Dogger Bank South Offshore Wind Farms

Environmental Statement

**Appendix 8-1 Marine Physical Environment
Consultation Responses**

Table 8-1-1 Consultation Responses Related to Chapter 8 Marine Physical Environment

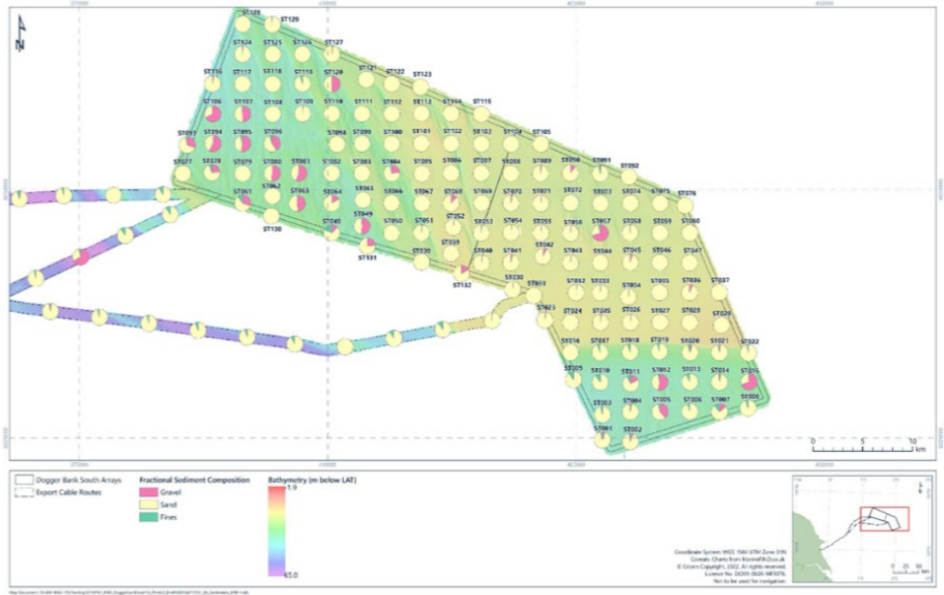
| Comment | Project Response | | | | | | | | | | | | | | | | | | | | | | | | | | | | |
|---|---|-----------------|-----------------|-----------------|-----------------|--------------------------|-----|-------|-----|--------------------------|-----|-------|-----|---------------|-----|-------|-------|---------------|-----|-------|-------|---------------|-----|-----|-----|-------------------|-----|-----|-------|
| NE9 - The wave and hydrodynamic model has not considered the influence of export cables (or array cables) owing to the fact they will be buried or only protrude a small height. Given that shallower depths across the cable route and array area these small protrusions could still be a significant proportion of the water column (in areas less than 10m) and therefore affect wave and hydrodynamics and should to be considered in more detail. | At this stage of the Projects, it is anticipated much of the export cable in areas less than 10m water depth will be buried and so there is limited requirement for cable protection measures to be required. Engineering work will determine this requirement as the Projects progress. Any changes in wave or tidal regimes caused by upstanding cable protection will manifest as an impact on bedload sediment transport in the nearshore zone. This has been considered as an impact in section 8.7.4.5 of Volume 7, Chapter 8 Marine Physical Environment (application ref: 7.8) . | | | | | | | | | | | | | | | | | | | | | | | | | | | | |
| NE10 - The sediment dispersal model only considers a situation where one monopile is installed per day for 24 days (with one day of concurrent piling). Will this be true for DBS or could concurrent piling occur more frequently? If so the impact this will have on the modelled data should be shown. | There is potential for three piles to be installed concurrently across the Offshore Development Area. Project-specific sediment dispersion rates from turbine foundation installation have been calculated in Volume 7, Appendix 8-3 Marine Physical Processes Modelling Technical Report (application ref: 7.8.8.3) . | | | | | | | | | | | | | | | | | | | | | | | | | | | | |
| NE11 - No frontal data / models are currently considered. Due to increased number and size of windfarm arrays research is starting to show an impact on frontal systems and primary production. | Potential impacts on the Flamborough Front and primary productivity are assessed in section 8.7.4.3 of Volume 7, Chapter 8 Marine Physical Environment (application ref: 7.8) . | | | | | | | | | | | | | | | | | | | | | | | | | | | | |
| <u>Differences between Creyke Beck and DBS array areas</u> | | | | | | | | | | | | | | | | | | | | | | | | | | | | | |
| NE12 - Whilst the depth of the two sites (Dogger Bank A&B and DBS) are similar when averaged, the topography is quite different. DBS is on the slope boundary of Dogger Bank so deeper and shallower depths are both expected. Has any consideration to the effect of this on sediment dispersal, wave height or wave shadow effect been completed. | <p>A comparison between the bathymetry of the two sites is given in Table 1-3 below. Site specific tidal ellipse data is detailed in section 8.5.5 of Volume 7, Chapter 8 Marine Physical Environment (application ref: 7.8).</p> <p><i>Table 1-3 Comparison of seabed elevation between DBS and other Dogger Bank Projects</i></p>

| Comment | Project Response |
|--|--|
| | <p>Figure 1 Seabed sediment composition within DBS array areas</p>  |
| <p>Environment Agency Responses to Marine Physical Processes Method Statement 16/01/2023²</p> | |
| <p>EA1 - Lessons learnt. The first scheme was apparently an overall success, it would be good to know that whatever issues arose during construction of the previous phases have been incorporated into the working understanding of the construction of the future works.</p> | <p>The DBA and DBB projects are in early phases of construction and therefore no post-construction monitoring reports were available to inform the assessment for DBS offshore wind farms.</p> |
| <p>EA2 - The summary report states that the proposed scheme is similar in sediment characteristics to the previous. How has this been investigated and characterised? Where there grab samples, boreholes showing the shallow strata, etc, that show what the bed and near bed sediment is made up of and how the two areas compare?</p> | <p>The comparison of sediment across the sites was based on bespoke sediment samples collected for the previous sites and overview data for DBS from the BGS archive. The results from site-specific benthic surveys and particle size analyses undertaken in 2022 have recently become available and the results are briefly summarised below in Table 1-4 and shown in Figure 1 and Figure 2. Based on this new data, we concluded that the seabed sediment composition is comparable between DBS and Dogger Bank A&B.</p> |
